APPENDIX A. Application Form: COA and Variance

TOWN OF CHESHIRE

From: Stacey Vairo
Sent: Monday, January 4, 2021 7:10 PM
To: Benny Huang (bennyhuang128@gmail.com)
Cc: gsitko@cheshirect.org
Subject: Ocular Window

From: Stacey Vairo <svairo@preservationct.org>
Sent: Wednesday, January 13, 2021 1:14 PM
To: Sitko, Jerry
Subject: Re: Ocular Window

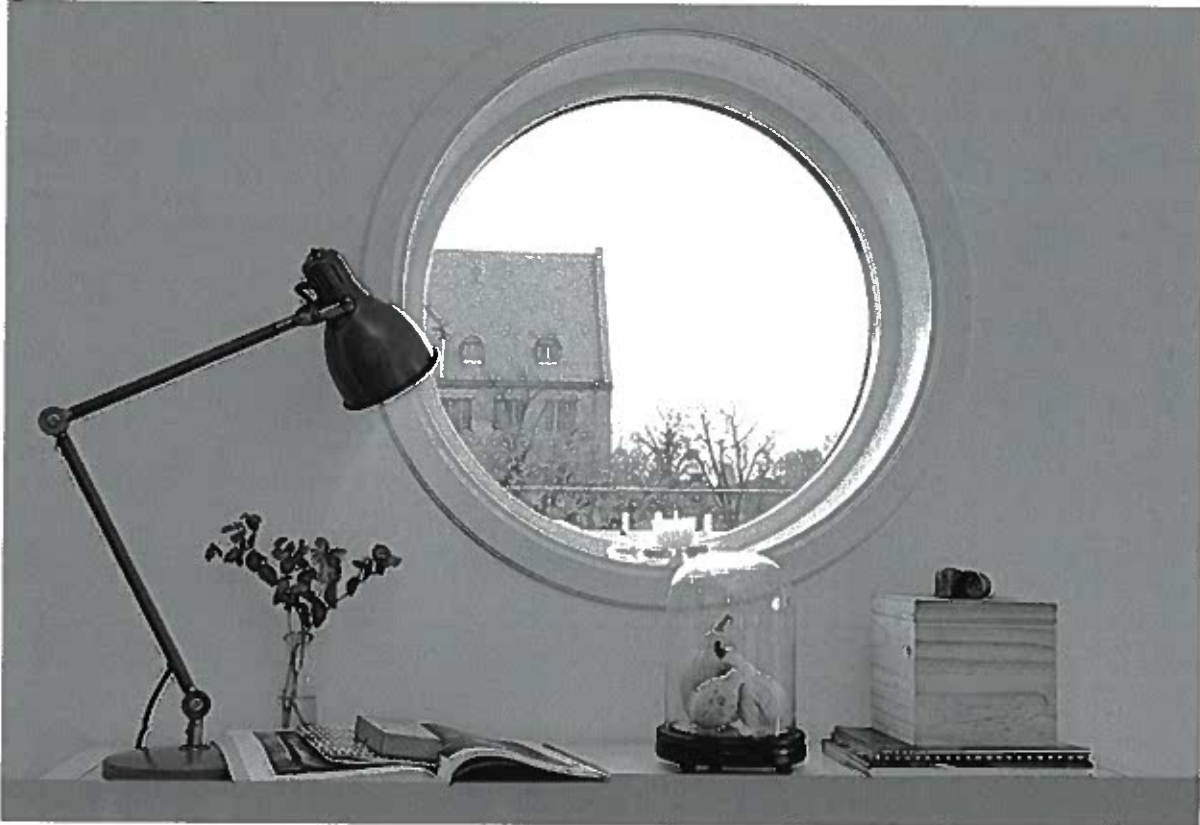
1. Which side is the one that will face the exterior the glass or the screen? If the screen is on the exterior, it seems that there is a good chance that the water from rain or wind will be captured in the unit and it will deteriorate really quickly. It should be sealed in some way as it is very likely that the original window was

simply one piece of glass that was fixed to the frame. Like this

one:

2. The way that the glass is attached to the wood using plastic clips is concerning. This is less about the way it looks and more about the longevity of the window unit itself. It seems that it would be very vulnerable to blowing out in a high wind or rotting because, again, it isn't a sealed joint. If you were to seal any openings where the glass meets the wood and then put a rounded trim over it to keep it in place the seal would be much stronger.

3. The finish on the window is very rough. This is not something that you can likely see from the street, so again this is less about looks and more about function. The rough surface will catch the dirt and moisture making the surface very vulnerable to rot. A good sanding and a thorough painting of the exposed wood is needed to ensure the window lasts.
